**MATANUSKA-SUSITNA BOROUGH
PLATTING BOARD
AGENDA**

OCTOBER 6, 2016

**OCTOBER 6, 2016
ASSEMBLY CHAMBERS
REGULAR MEETING
1:00 P.M.**

Drainage Arrow Scale 1" = 250' Date: 8/2/2016

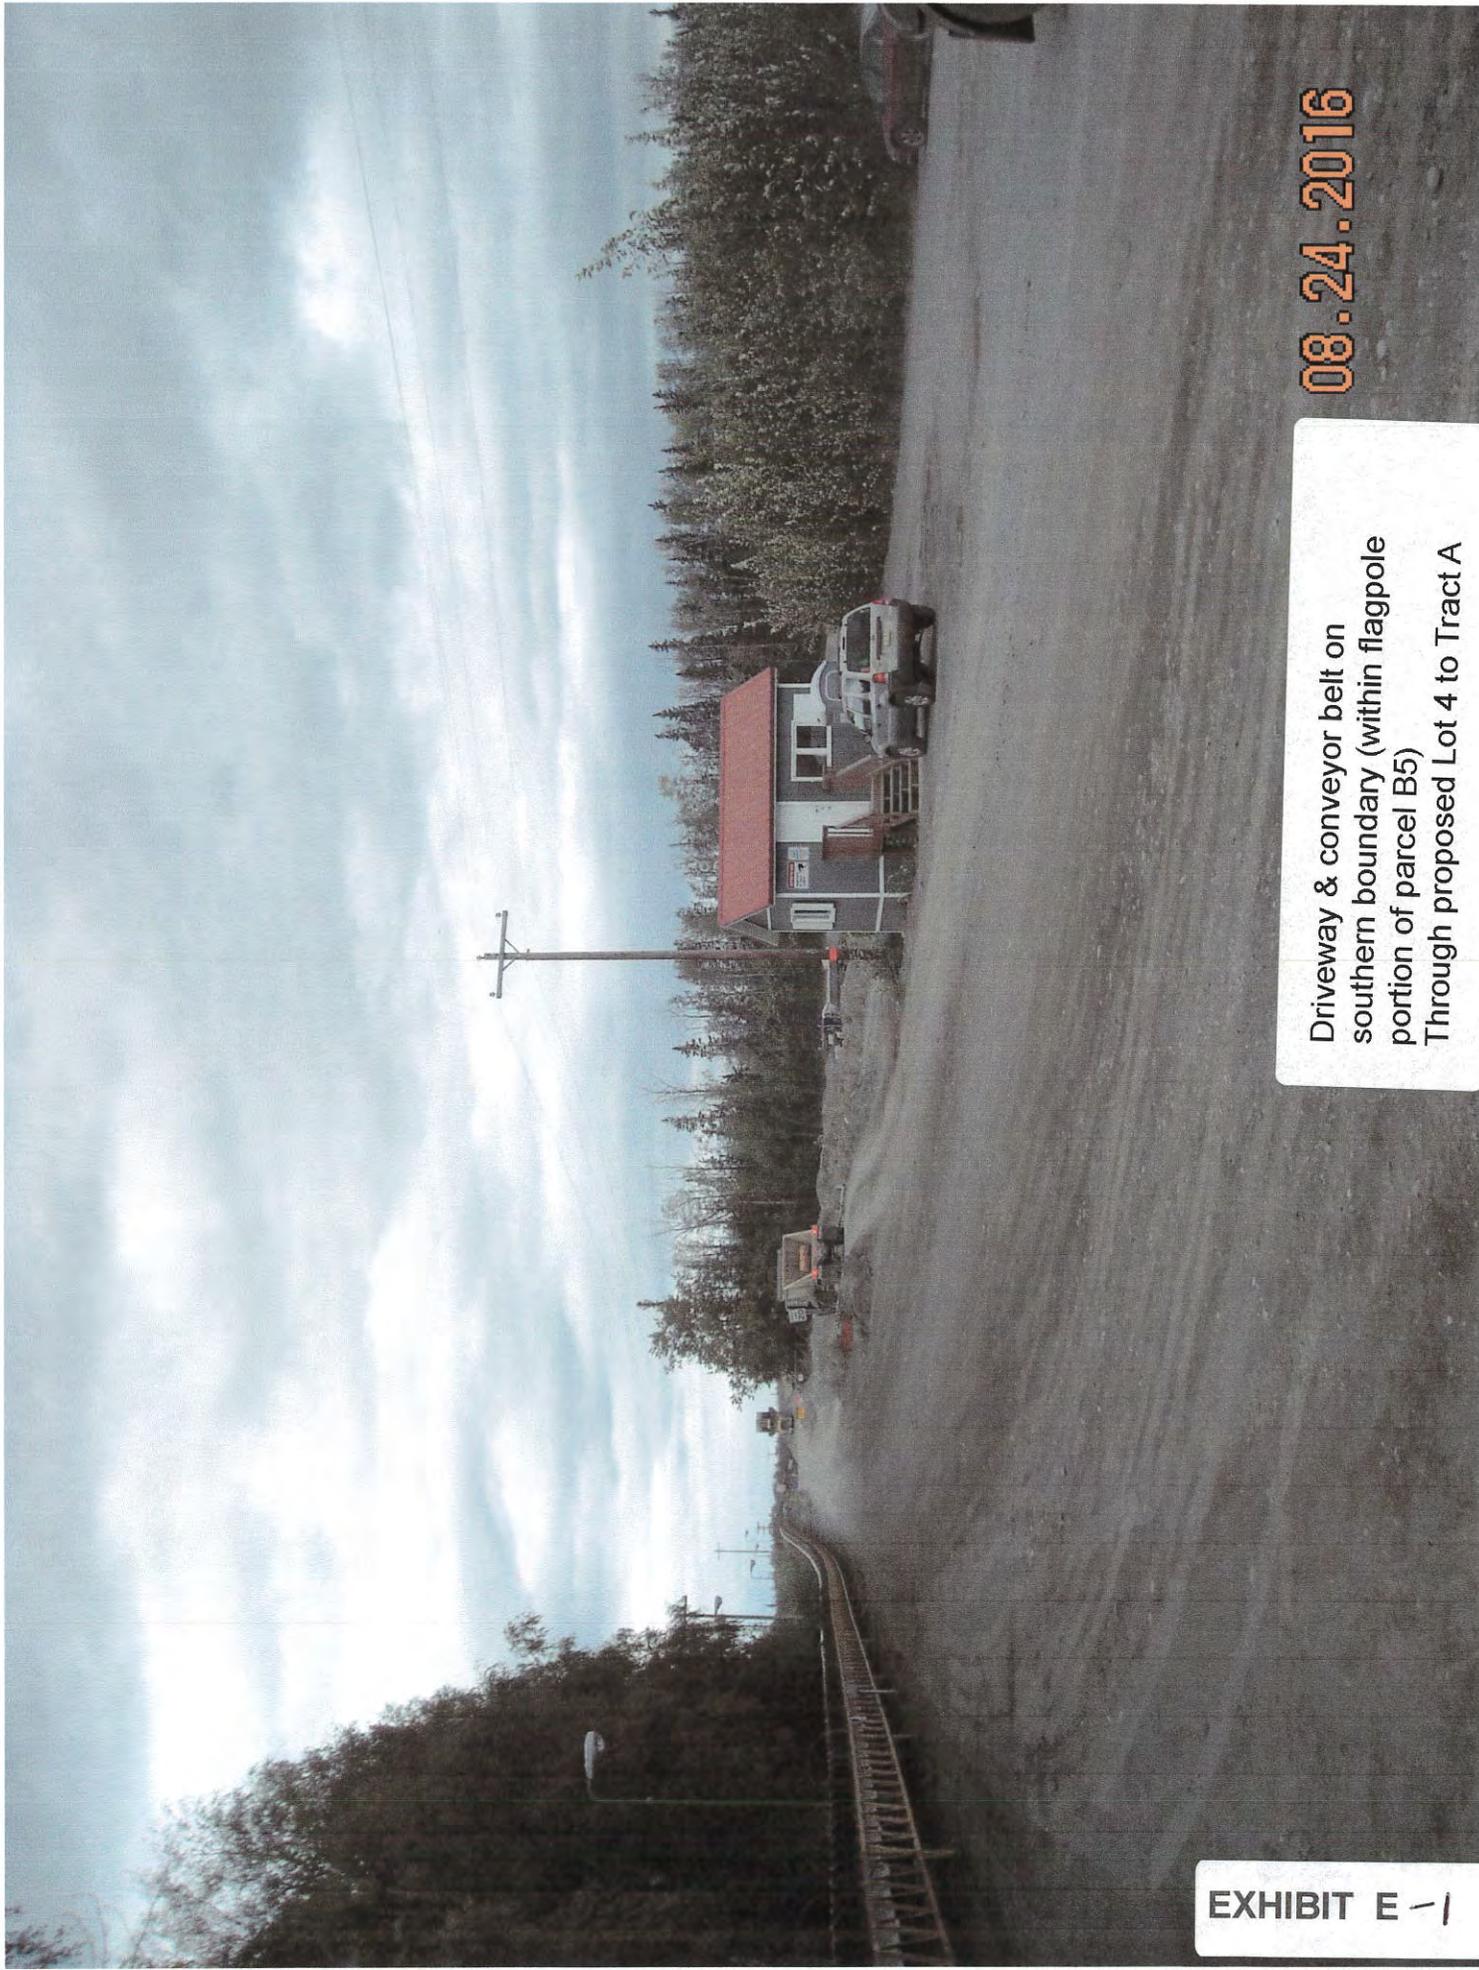
Topo/Drainage/As-Built: The Topographic Map includes drainage and as-built information. The map shows the general drainage patterns and the proposed road and lots. The location of the conveyor belt and building are shown on Lot 4 and Tract A. Staff notes the drainage plan may change during road construction. **(Exhibit D)**

MSB Department of Public Works stated all cut/fill should fit in right-of-way and a drainage easement and a cross pipe may be needed. Staff notes the drainage plan didn't reflect any cross pipe or drainage easement but this may be subject to change as the road is constructed. **(Exhibit H)**

8. Provide final drainage plan and if necessary, install cross pipe and show drainage easement.
9. Taxes and special assessments must be current prior to recording, pursuant to MSB 43.15.053(F) and AS 40.15.020. Pay taxes and special assessments (LIDs) by certified funds or cash.

EXHIBIT E - 1

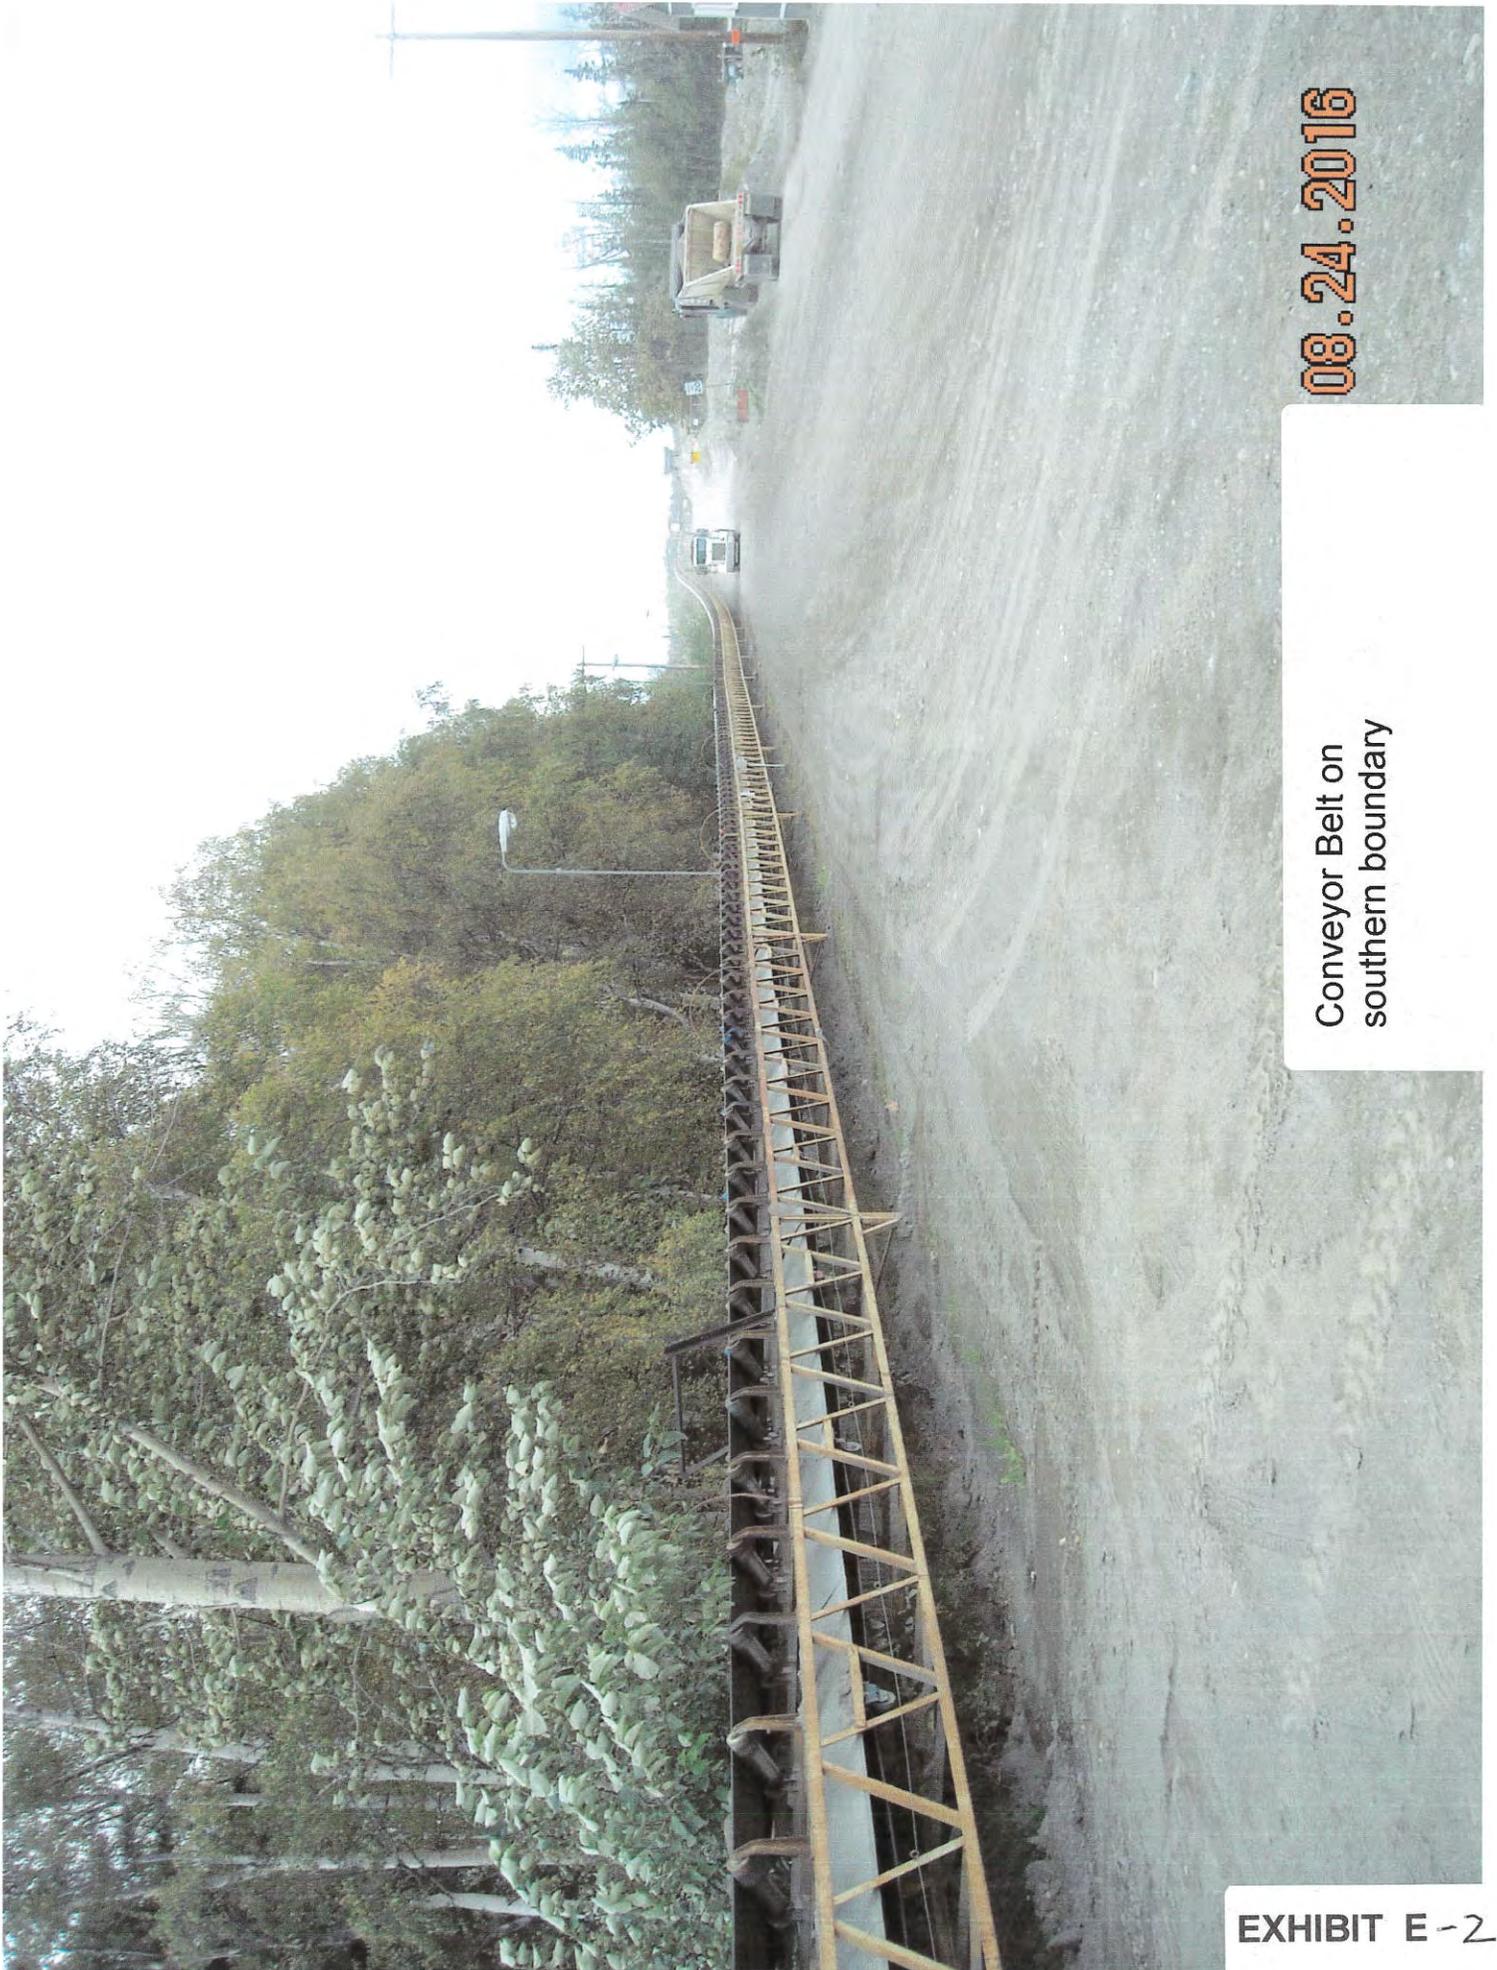
MSB Planning stated the conveyor belt may extend up to railroad right-of-ways and does not violate any structural setback requirements due to it being rail dependent per MSB Code 17.55.010(G). **(Exhibit F)**

Conveyor is rail dependent
per Susan LEE/Planning
8/11/16
